**APPLICATION OF SOUTHERN CALIFORNIA GAS COMPANY FOR AUTHORITY TO RECOVER VENTURA COMPRESSOR MODERNIZATION PROJECT REVENUE REQUIREMENT IN CUSTOMER RATES AND FOR APPROVAL OF RELATED COST ALLOCATION AND RATE DESIGN PROPOSALS (A.23-08-019)**

**DATA REQUEST Cal Advocates-SCG-01**

**Date Requested: November 15, 2023, Submitted: December 4, 2023**

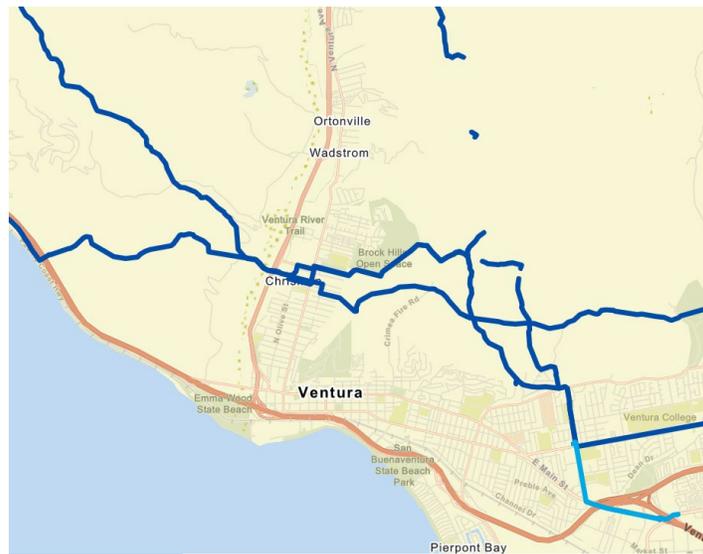
**QUESTION 1:** The following is a screenshot accessed on 11/14/2023 of the Ventura County map on SoCalGas' natural gas transmission mapping website, <https://www.socalgas.com/stay-safe/pipeline-and-storage-safety/natural-gas-pipeline-map>. This shows the transmission pipeline(s) currently feeding into the Ventura Compressor Station.

For the three alternative locations in the Application (denoted below) which would relocate the Ventura Compressor Station, please identify the number of miles of existing transmission pipelines that would need to be removed, shut in, abandoned-in-place, or taken out of service. Please also estimate the number of miles of additional, new transmission pipeline which would need to be installed in order to bring this alternate location online.

- a. Alternative Location 1: Avocado Site
  - i. Removed
  - ii. Shut in
  - iii. Abandoned in place
  - iv. Taken out of service
  - v. Additional new

- b. Alternative Location 2: Devil's Canyon Road
  - i. Removed
  - ii. Shut in
  - iii. Abandoned in place
  - iv. Taken out of service
  - v. Additional new

- c. Alternative Location 3: Ventura Steel
- i. Removed
  - ii. Shut in
  - iii. Abandoned in place
  - iv. Taken out of service
  - v. Additional new

- 
- i. Removed - The existing alignment to the new segment would conceptually require an amount of pipe to be cut and removed to allow for the new tie-ins. An estimate for the amount of pipe to be removed has not been determined at this time since preliminary engineering has not been performed.

- ii. Shut in – Preliminary engineering would need to be performed to determine the pipeline mileage impacted by the new segments tie-in.
  - iii. Abandoned in place – Since preliminary engineering has not been performed, it is assumed this alternative would not involve abandonment of pipeline in place.

- iv. Taken out of service – Preliminary engineering would need to be performed to determine if any pipeline segment would be taken out of service for this alternative.

- v. Additional new – Conceptually, the Avocado site alternative will require approximately 0.18 miles of new pipeline system based on conceptual routing from the map provided in the PEA. This system consists of two suction pipelines and two discharge pipelines with a combined total of approximately 0.36 miles. Additionally, the pipeline within the existing station may also require reconfiguration to allow gas flow to the new location. Detailed engineering would need to be performed to verify the estimate.

- b. Alternative Location 2: Devil’s Canyon Road
- i. Removed – The existing alignment to the new segment would conceptually require an amount of pipe to be cut and removed to allow for the new tie-ins. An estimate for the amount of pipe to be removed has not been determined at this time since preliminary engineering has not been performed.

- ii. Shut in - Preliminary engineering would need to be performed to determine the pipeline mileage impacted by the new segments tie-in.
  - iii. Abandoned in place – Since preliminary engineering has not been performed, it is assumed this alternative would not involve abandonment of pipeline in place.

- iv. Taken out of service - Preliminary engineering would need to be performed to determine if any pipeline segment would be taken out of service for this alternative.

- v. Additional new – Conceptually the Devil’s Canyon site alternative will require approximately 0.97 miles of new pipeline system based on the conceptual routing from the map provided in the PEA. This system consists of two suction pipelines and two discharge pipelines with a combined total of approximately 1.94 miles. Additionally, the pipeline within the existing station may also require reconfiguration to allow gas flow to the new location. Detailed engineering would need to be performed to verify this estimate.

- c. Alternative Location 3: Ventura Steel
- i. Removed – The existing alignment to the new segment would require an amount of pipe to be cut and removed to allow for the new tie-ins. The exact estimate would require detailed engineering which has not been performed.

- ii. Shut in - Preliminary engineering would need to be performed to determine the pipeline mileage impacted by the new segments tie-in.
  - iii. Abandoned in place – Since preliminary engineering has not been performed, it is assumed this alternative would not involve abandonment of pipeline in place.

- 
- iv. Taken out of service - Preliminary engineering would need to be performed to determine if any pipeline segment would be taken out of service for this alternative.
  - v. Additional new – Conceptually the Ventura Steel site alternative will require approximately 4.93 miles of new pipeline system based on the conceptual routing from the map provided in the PEA. This system consists of two suction pipelines and two discharge pipelines with a combined total of approximately 6.39 miles. Additionally, the pipeline within the existing station may also require reconfiguration to allow gas flow to the new location. Detailed engineering would need to be performed to verify this estimate.
